ADDENDUM NO. 1

December 26, 2023

**TO PROSPECTIVE BIDDERS UNDER
Fenter Rd Reconstruction
LVWD Bid No. 24-0105-02**

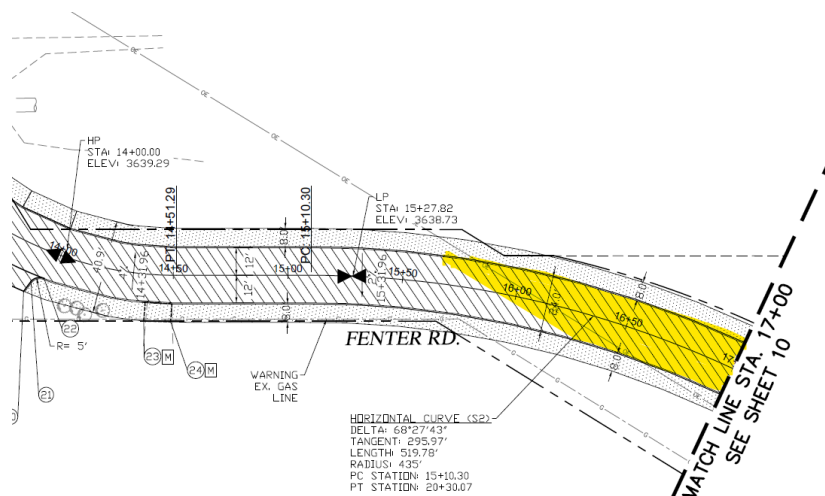
The estimated range for the Base Bid 1 is between \$690,000 and \$720,000.

Sheet reference number:
Sheet 02 of 29

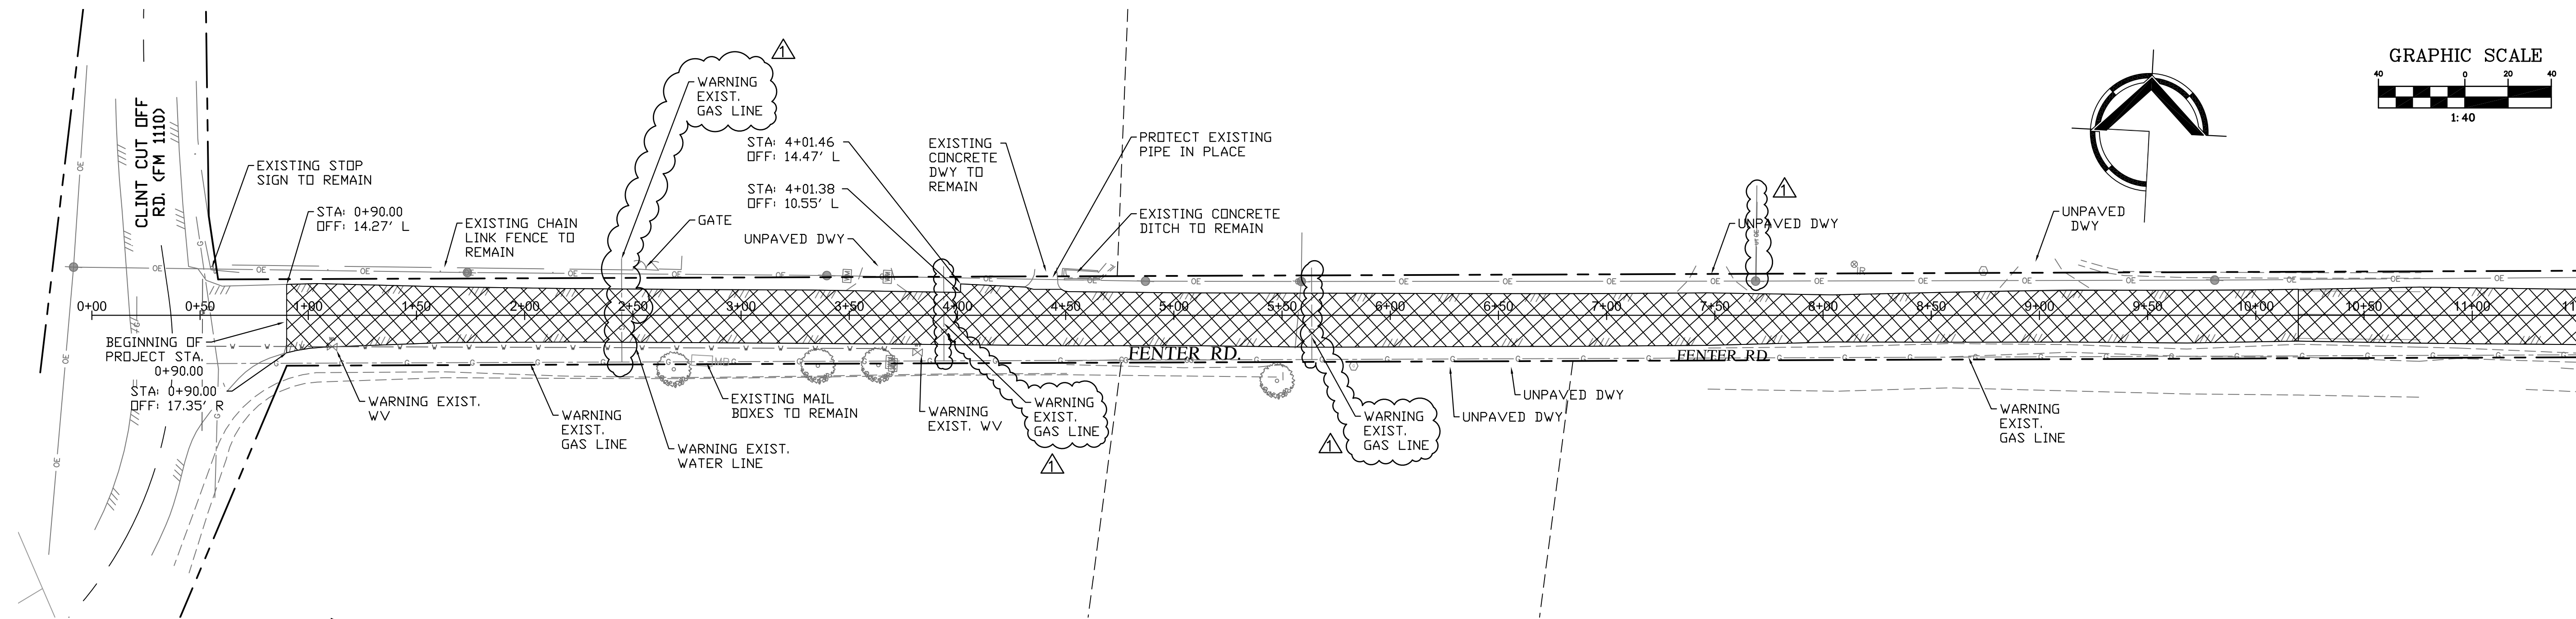
- On Plan Sheet Number 2 of 29; GRADING SPECIFICATIONS Note 12. States the following “ IN AREA\S WHERE PUMPING OCCURS, THE CONTRACTOR SHALL REMOVE THE SATURATED MATERIAL AND REPLACE WITH CEMENT STABILIZED BACKFILL (2-SACK). THIS SHOULD BE SUBSIDIARY TO ITEM 13 COMPACTED SELECT FILL AND ITEM 14 SUBGRADE PREPARATION. It is unknown if pumping will occur or not. How much 2-Sack should we include on these bid items?

Item No.	Page or Drawing No.	Location and Description of Change
1.16	Sheet 2	<p>DELETE Sheet 2 in its entirety and REPLACE with Sheet 3 in Attachment 18.</p> <p>Note 12 was modified to clarify when cement stabilized backfill is required for areas with pumping issues.</p>

Sheet reference number:
 Sheet 06 of 29

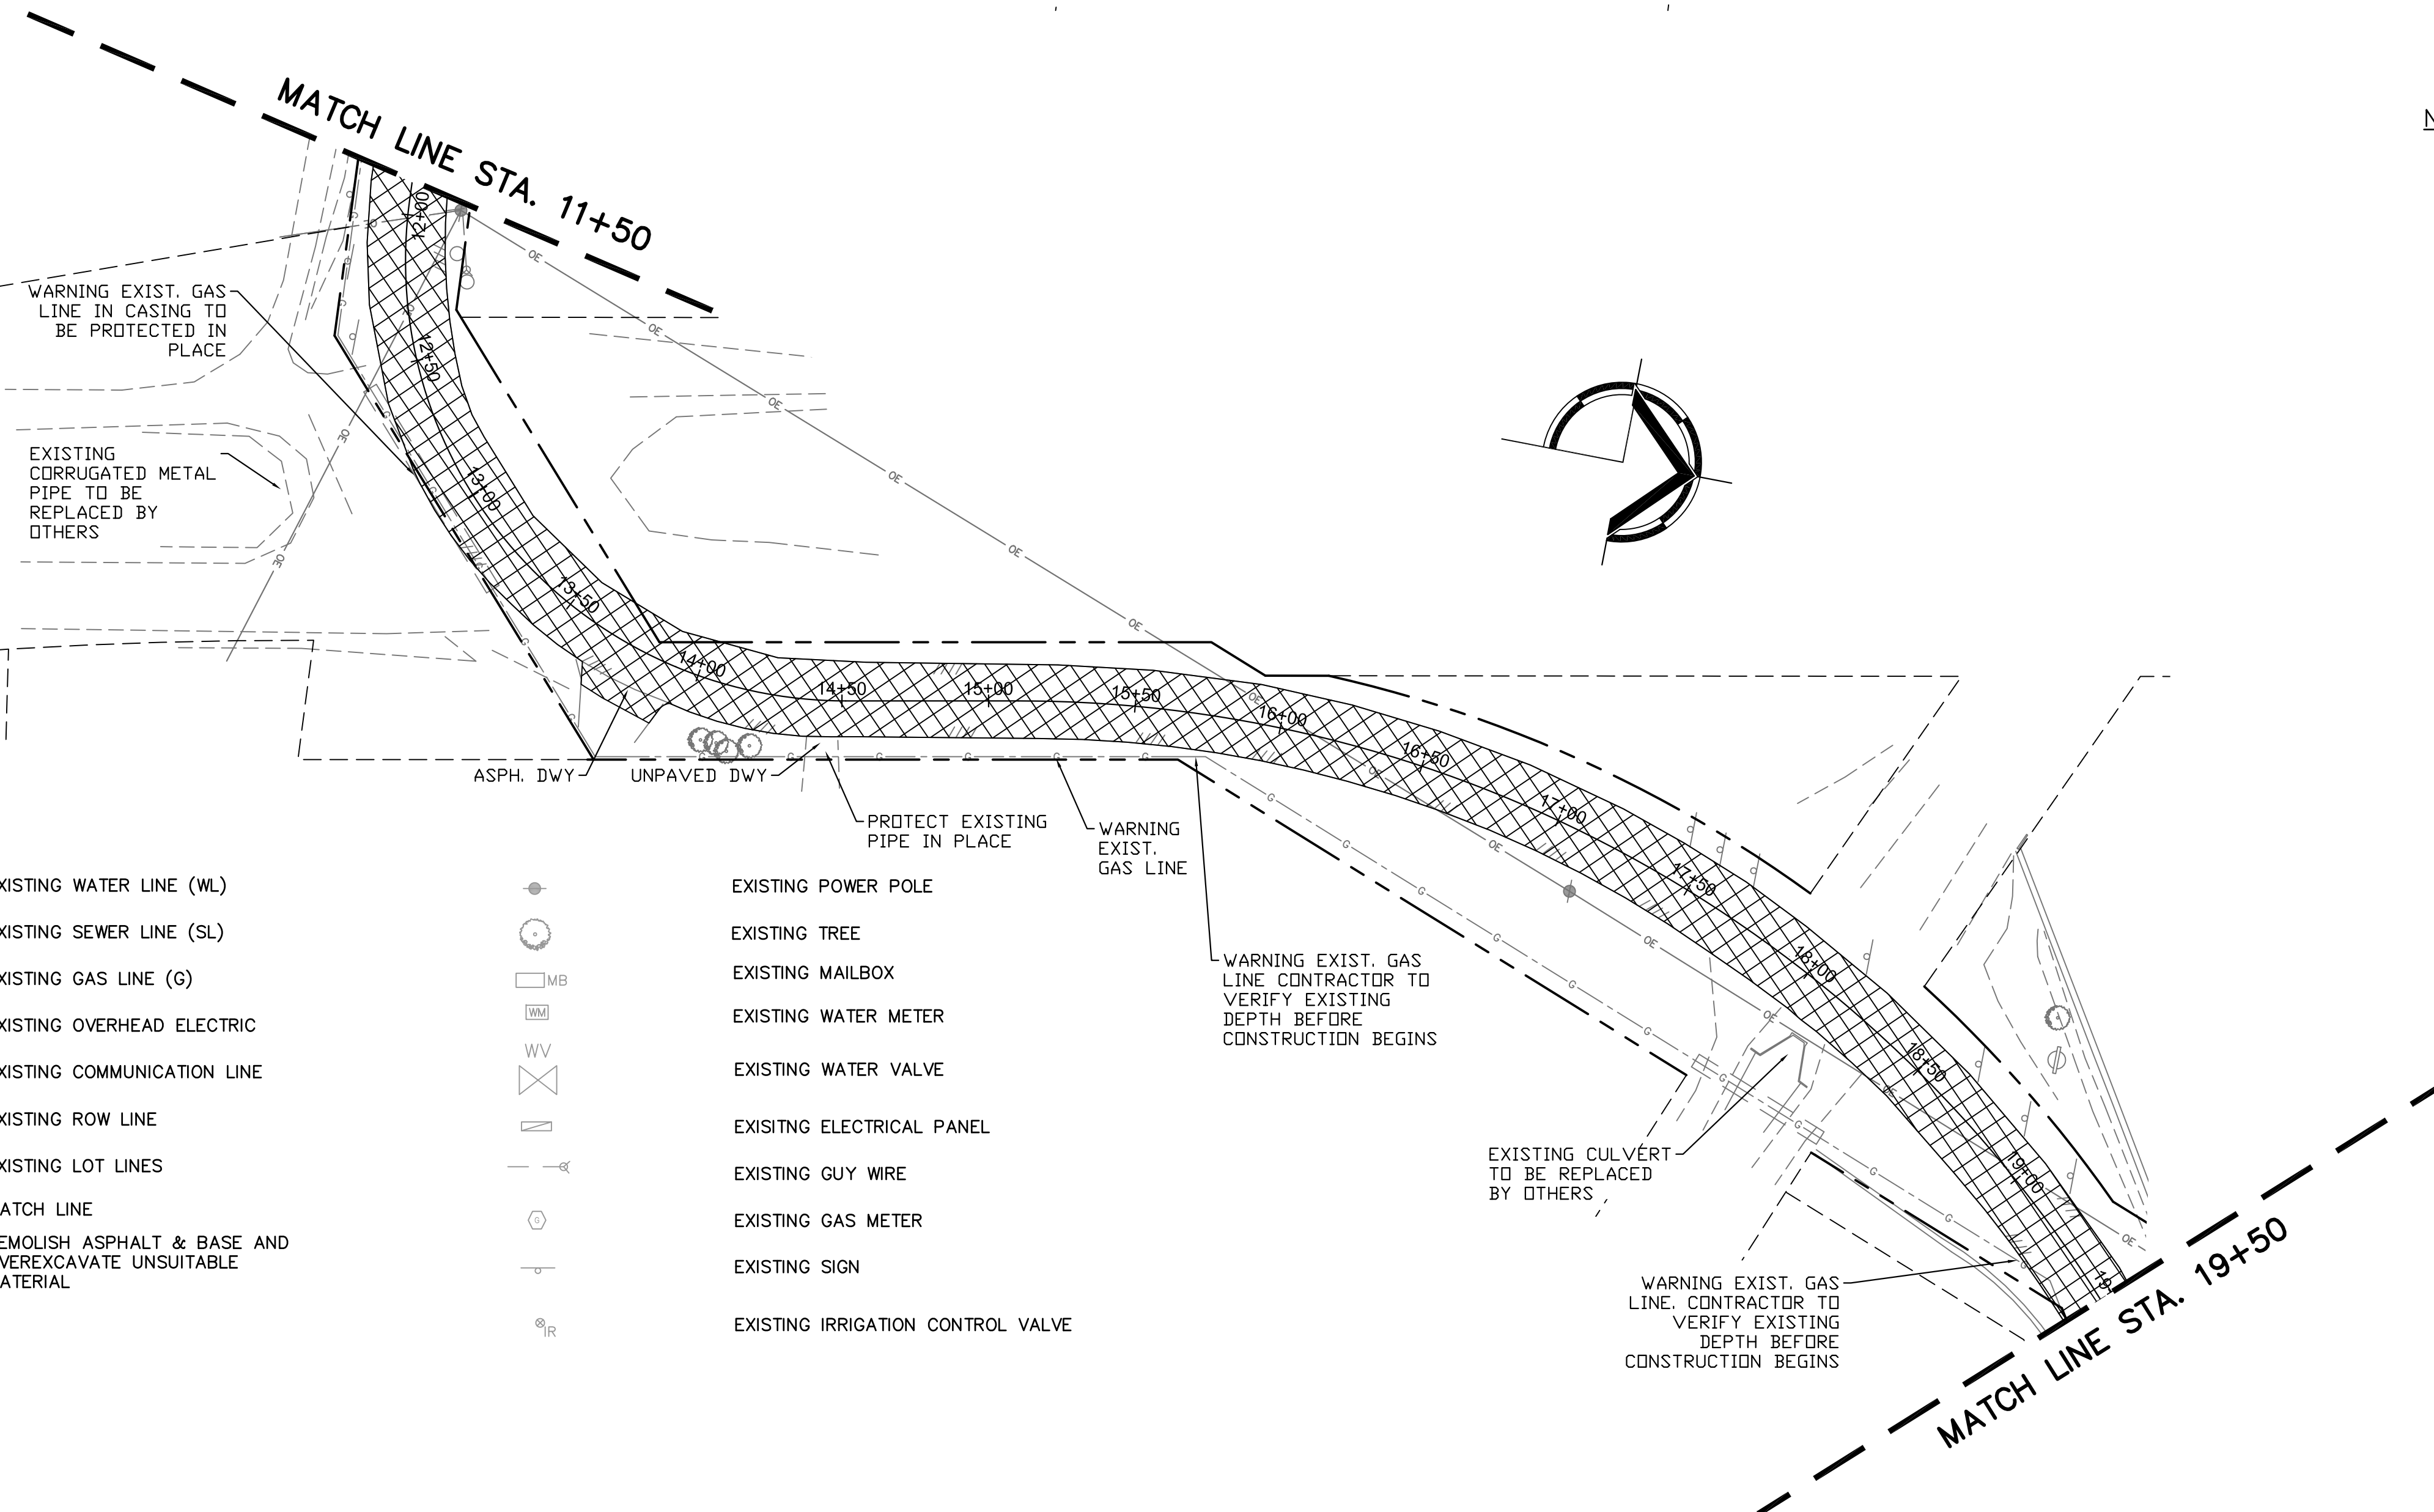
1.17	Sheet 5	<p>DELETE Sheet 5 in its entirety and REPLACE with Sheet 5 in Attachment 18.</p> <p>Identified existing gas lines and underground communication lines that were missing from original plans. The legend was also updated to show the correct line type for existing underground communication lines.</p>

1.18	Sheet 6	<p>DELETE Sheet 6 in its entirety and REPLACE with Sheet 6 in Attachment 18.</p> <p>The legend was updated to show the correct line type for existing underground communication lines.</p>

Sheet reference number:
 Sheet 07 of 29

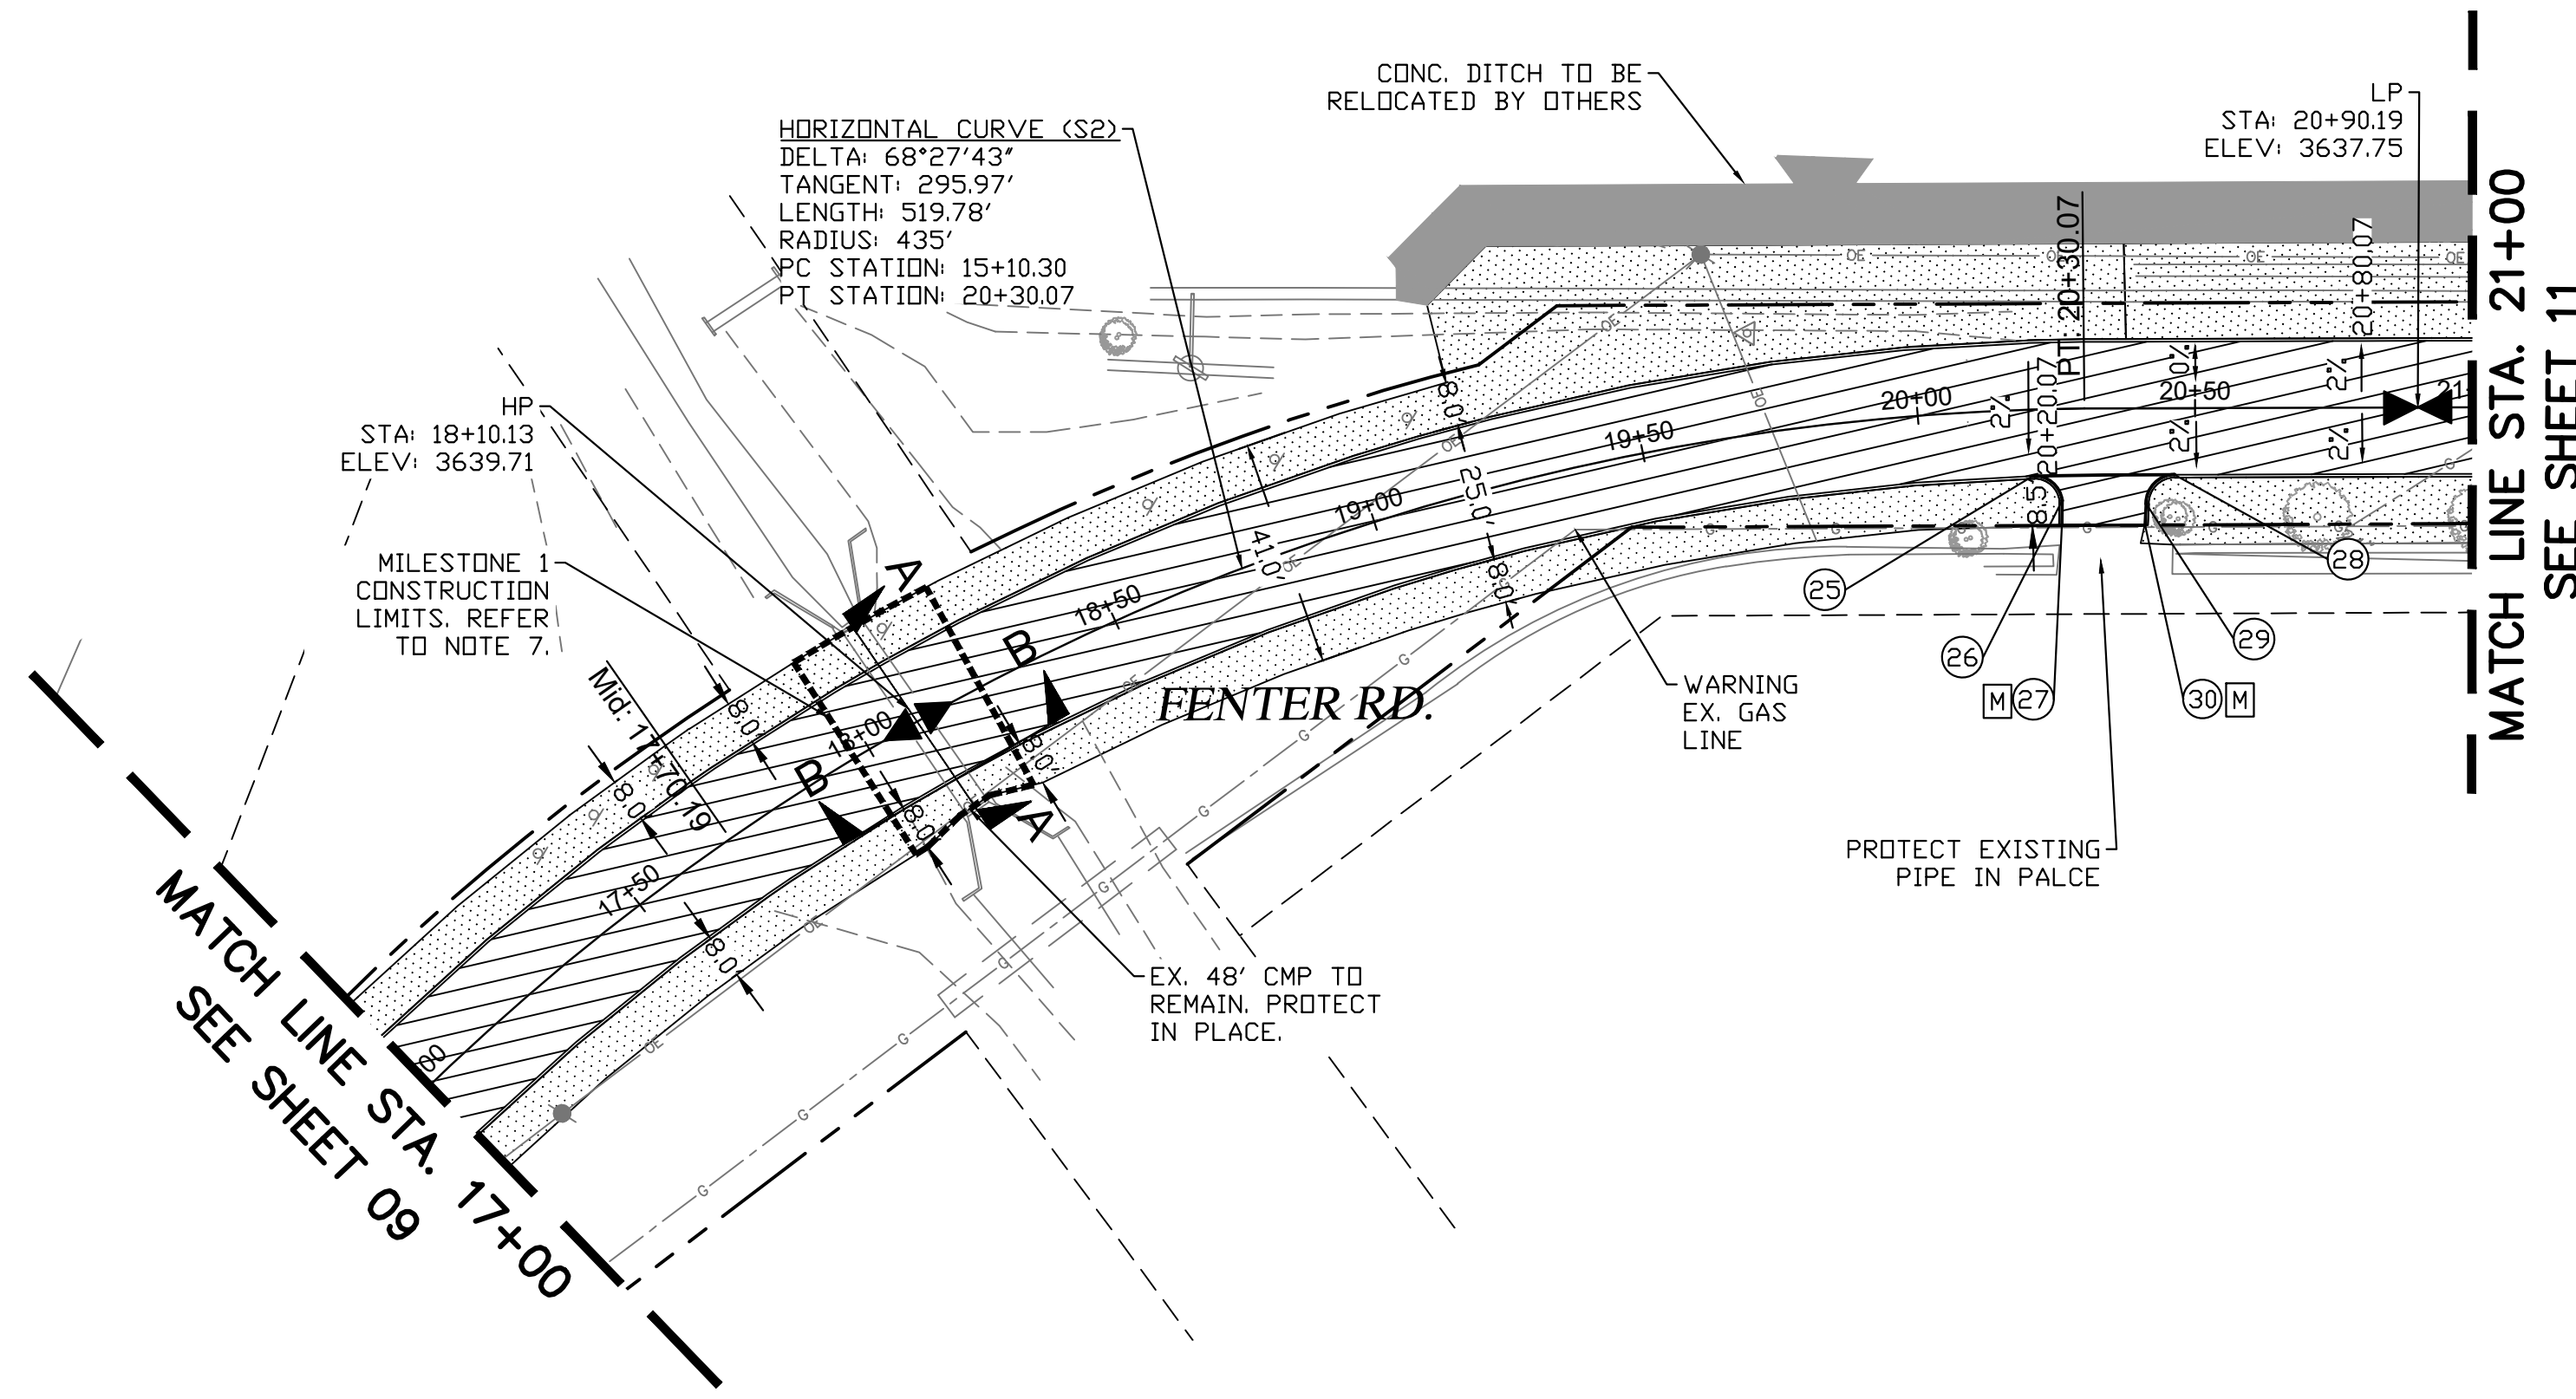
1.19	Sheet 7	<p>DELETE Sheet 7 in its entirety and REPLACE with Sheet 7 in Attachment 18.</p> <p>Identified existing gas lines that were missing from original plans.</p>
